**VILLAGE OF LAKE BLUFF  
ARCHITECTURAL BOARD OF REVIEW**

**Tuesday, October 3, 2017 – 7:00 P.M.**

**SUBJECT:** **Agenda Item #4 - Consideration of a Sign Permit Application for the Lake Bluff Commerce Center at 910 Sherwood Drive and 42 Sherwood Terrace**

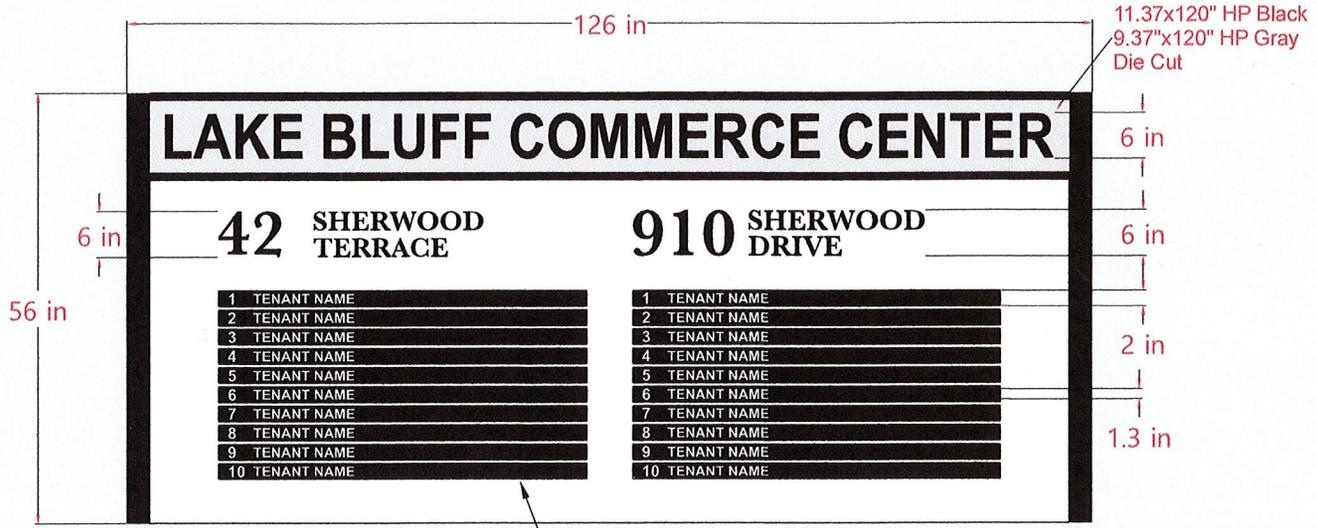
The owner of the two multi-tenant buildings at 910 Sherwood Drive and 42 Sherwood Terrace, known as the Lake Bluff Commerce Center, is proposing to replace their two existing monument signs with two new identical signs. The new signs will be single-sided with black graphics on a white background. The back of the signs will be white. They will be the same size as the existing signs.

<b>Sign Code L-1</b>	<b>Proposed Signage</b>
1.) Corner lots are permitted 2 ground signs	Complies
2.) Maximum Sign Area is 64 square feet	Complies, each sign is 49 sq ft
3.) Maximum Sign Height is 20'	Complies, 4'-8" tall
